**Re: In the Matter of the City of Hays' and the City of Russell's Applications for Approval to Change the Place of Use, the Point of Diversion and the Use Made of the Water Under an Existing Water Right, regarding the R9 Water Rights (i.e., regarding the Master Order issued March 28, 2019); Preliminary Municipal Well Legal Descriptions**

Re: Hays/Russell/R9 Ranch Proposed Municipal Well Locations

Re: Municipal Well Locations

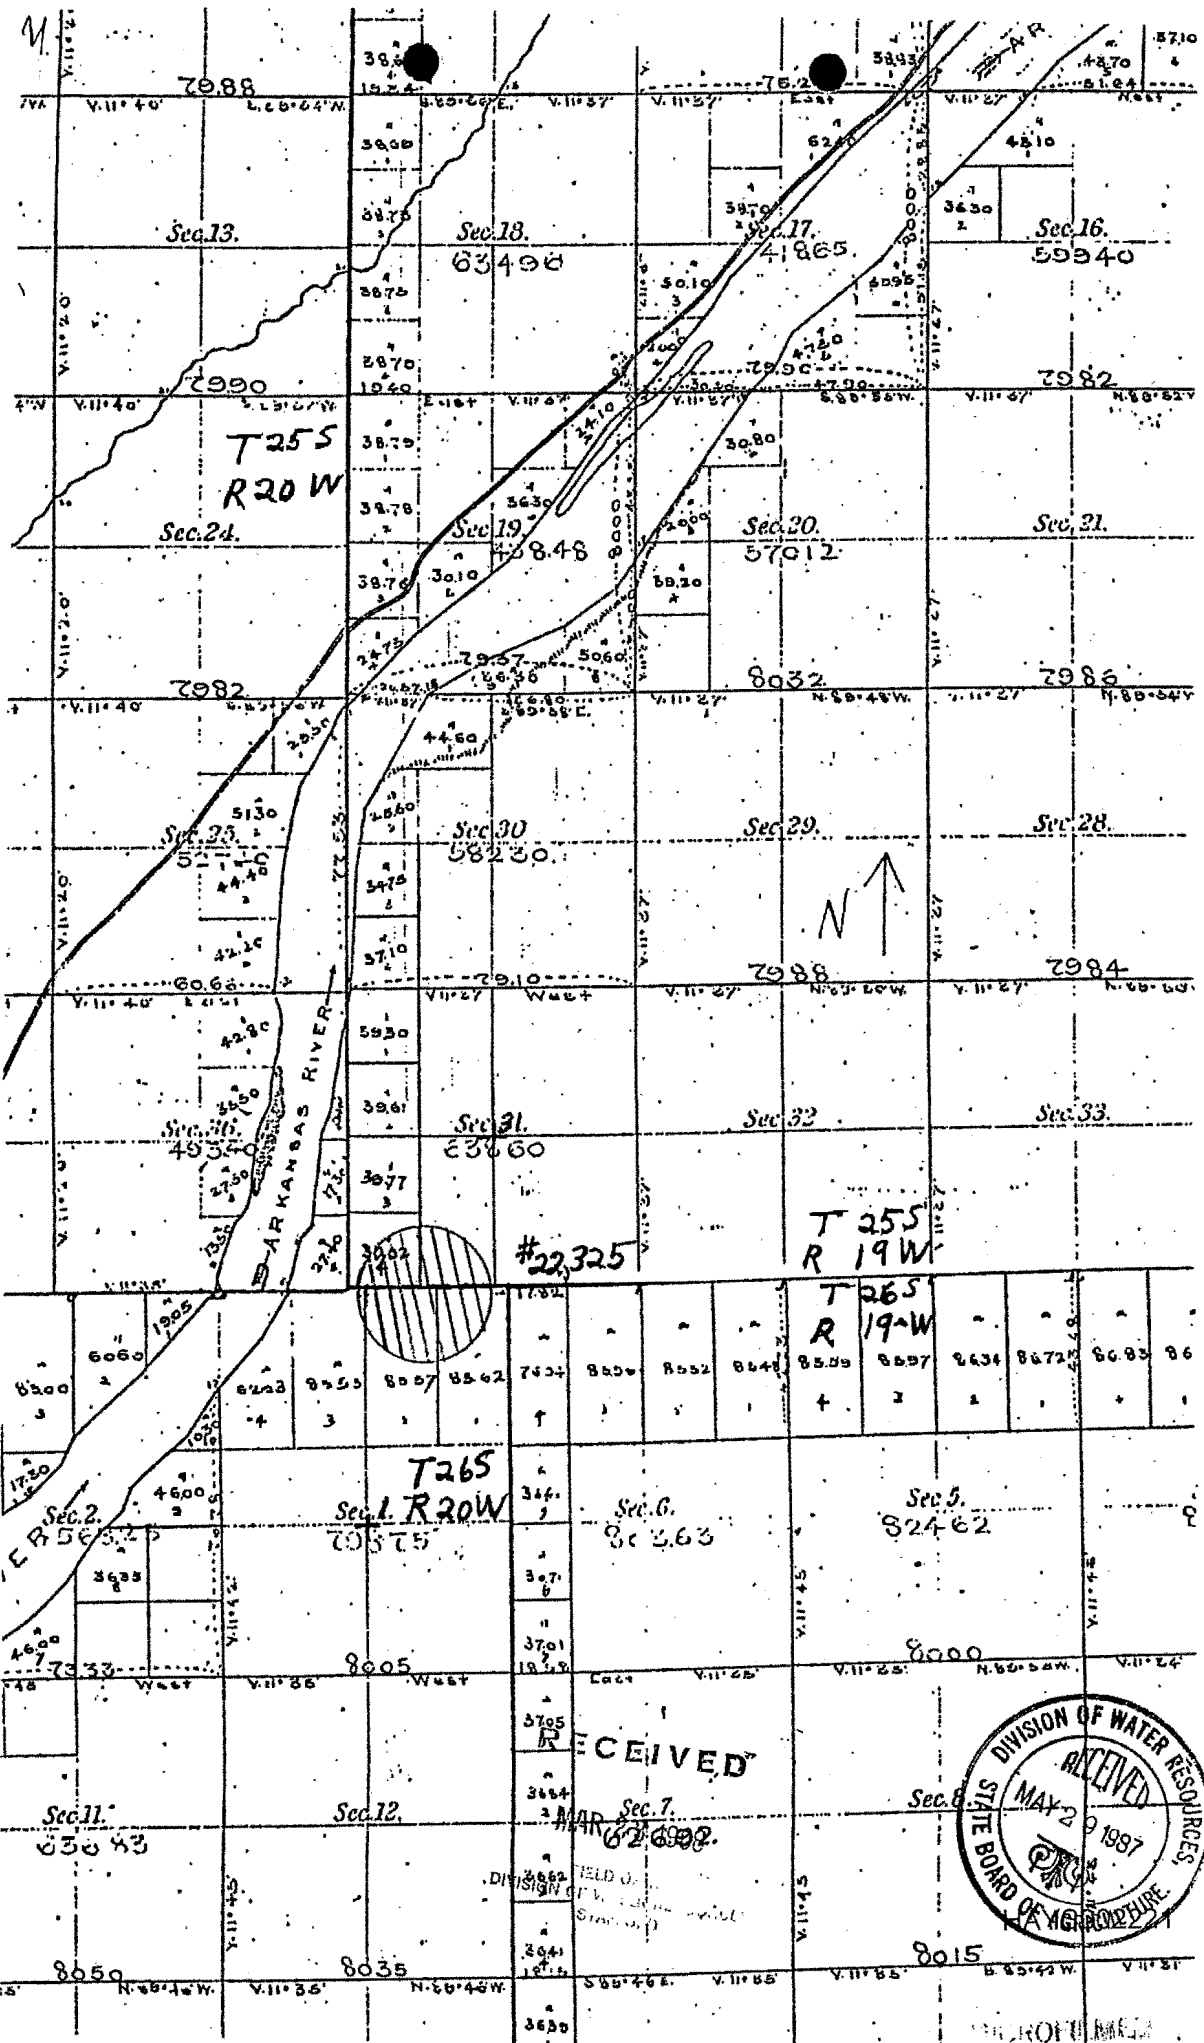
The distances are different because, as shown in the attached images, the Sections are not perfectly square and North/South (T25S/T26S) and East/West (R19W/R20W) corrections lines intersect in the middle of the Ranch.

Assuming the accuracy of the KGS PLSS Sections layer, which was also assumed for the previous descriptions, Mr. Clement calculated the distances North and West of the Southeast Section Corners and the UTM NAD83 coordinates for each well. The distances of each proposed well location from the Section Lines, from the Southeast Section corners, and the differences are shown in the attached table.

Revised Municipal Well Locations	
A	A well in the SE/4 of the NE/4 of the NE/4 of the SW/4 of Section 29 T25S-19W, 2,264 Feet North and 2,568 Feet West of the SE Corner of the Section.
B	A well in the SW/4 of the SE/4 of the SW/4 of the NE/4 of Section 32 T25S-19W, 2,748 Feet North and 1,714 Feet West of the SE Corner of the Section.
C	A well in the SE/4 of the NE/4 of the SE/4 of the SW/4 of Section 33 T25S-19W, 830 Feet North and 3,019 Feet West of the SE Corner of the Section.
D	A well in the NW/4 of the NE/4 of the SE/4 of the NW/4 of Section 5 T26S-19W, 4,806 Feet North and 3,036 Feet West of the SE Corner of the Section.
E	A well in the NE/4 of the NW/4 of the SE/4 of the SE/4 of Section 5 T26S-19W, 1,549 Feet North and 880 Feet West of the SE Corner of the Section.
F	A well in the SW/4 of the NW/4 of the SE/4 of the NE/4 of Section 4 T26S-19W, 4,553 Feet North and 1,260 Feet West of the SE Corner of the Section.

G	A well in the SW/4 of the NW/4 of the NE/4 of the SW/4 of Section 30 T25S-19W, 2,278 Feet North and 3,779 Feet West of the SE Corner of the Section.
H	A well in the NE/4 of the SW/4 of the SW/4 of the NE/4 of Section 31 T25S-19W, 3,144 Feet North and 1,882 Feet West of the SE Corner of the Section.
I	A well in the SE/4 of the SE/4 of the NE/4 of the NW/4 of Section 1 T26S-20W, 5,132 Feet North and 2,908 Feet West of the SE Corner of the Section.
J	A well in the NE/4 of the NE/4 of the SW/4 of the SW/4 of Section 1 T26S-20W, 1,634 Feet North and 4,078 Feet West of the SE Corner of the Section.
K	A well in the SE/4 of the NW/4 of the SW/4 of the NE/4 of Section 11 T26S-20W, 3,630 Feet North and 2,141 Feet West of the SE Corner of the Section.
L	A well in the NE/4 of the SW/4 of the NE/4 of the SE/4 of Section 10 T26S-20W, 1,862 Feet North and 882 Feet West of the SE Corner of the Section.
M	A well in the NW/4 of the SW/4 of the NE/4 of the NE/4 of Section 15 T26S-20W, 4,370 Feet North and 1,167 Feet West of the SE Corner of the Section.

N	A well in the NW/4 of the SW/4 of the NW/4 of the SE/4 of Section 15 T26S-20W, 1,725 Feet North and 2,421 Feet West of the SE Corner of the Section.
